Access Compliance Report

Public Rights-of-Way

Intersection ID: 18152	Main Street: BEECHDALE_DR	Cross Street: OLD_POST_RD	Location: E
ADA ID: F796BDD30C6F	Ramp Type: PerpDiag	Initial Pass/Fail: Fail	Overall Compliance: No
Severity Score: 10			
Codes/Mitigation Info/Possible Solution		Field Measurements/Component Compliance

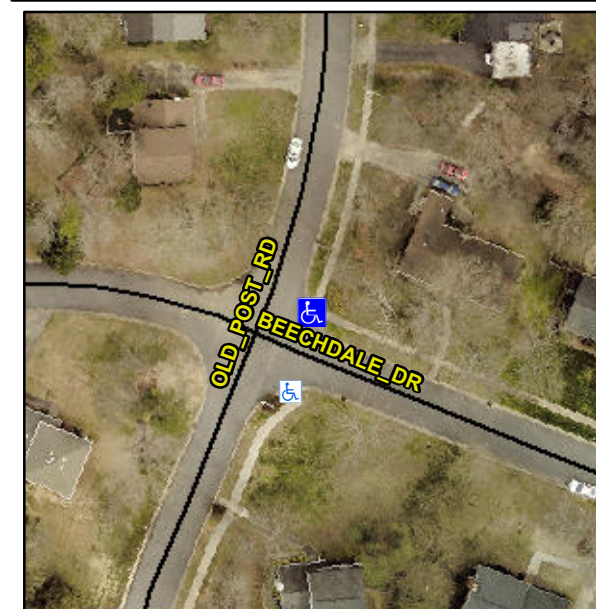
Not Found, R304.5.1, R304.5.3

Compliance	Description	Data	Compliance	Description	Data
N/A	Ramp Length (in)	41.0	Yes	Ramp Slope (%)	5.5
No	Ramp Width (in)	36.0	No	Ramp XSlope (%)	2.9
N/A	Flare Type LT	N/A	N/A	Flare Type RT	N/A
N/A	Flare Slope LT (%)	N/A	N/A	Flare Slope RT (%)	N/A
N/A	Flare Traversable LT?	N/A	N/A	Flare Traversable RT?	N/A
N/A	Landing Length (in)	N/A	N/A	DWS Provided?	N/A
N/A	Landing Width (in)	N/A	N/A	DWS Contrast?	N/A
N/A	Landing Slope (%)	N/A	N/A	DWS Length (in)	N/A
N/A	Landing X Slope (%)	N/A	N/A	DWS Full Width?	N/A
N/A	Landing Curb? (Y/N)	N/A	N/A	DWS Offset (in)	N/A
N/A	Shared Landing?	N/A			
N/A	Gutter Ponding?	N/A	N/A	Gutter Slope (%)	N/A
N/A	Gutter Lip Ht (in)	N/A	N/A	Gutter X Slope (%)	N/A
N/A	Painted X Walk1?	No	N/A	Painted X Walk2?	No
	X Walk 1 Direction	To NW		X Walk 2 Direction	To SW
N/A	X Walk 1 Width (in)	N/A	N/A	X Walk 2 Width (in)	N/A
	X Walk 1 Slope (%)	3.0		X Walk 2 Slope (%)	0.1
	X Walk 1 X Slope (%)	1.2		X Walk 2 X Slope (%)	4.3

Remove & Replace Curb Ramp With Two New Directional Ramps or Equivalent.
